To: Users of SFI Specs 2.6
From: SFI Foundation, Inc.
Subject: Spec 2.6C, Revision, effective December 3, 2021

The above referenced SFI Specs for Front Engine Dragster Roll Cage 7.50 Seconds and Slower have been revised, effective December 3, 2021. The revised version is designated as SFI Specs 2.6C and is immediately available from SFI for use by sanctioning bodies and chassis builders.

Section III.1.b:

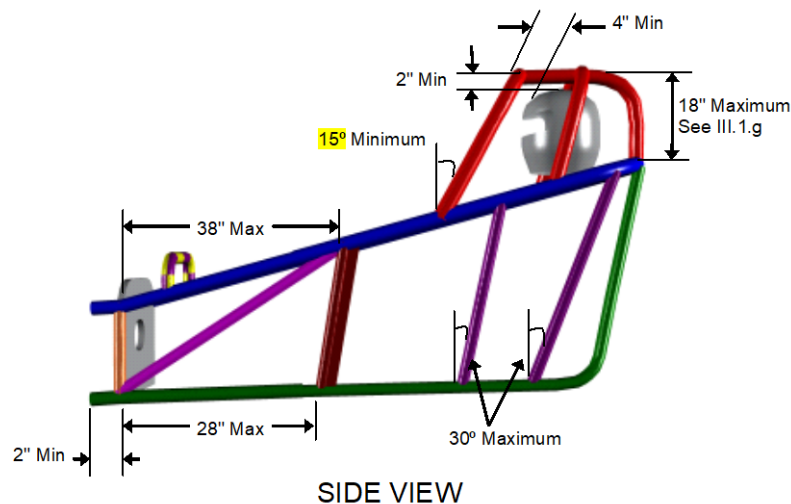
- The forward roll cage hoop (#1) must be installed to shoulder hoops (#3) at a minimum angle of 15° from vertical. For requirements of chassis built prior to 2010 with a forward roll cage hoop angle less than 15° from vertical consult the "SFI 2.6 Legacy Tech Advisory" document available from SFI.**
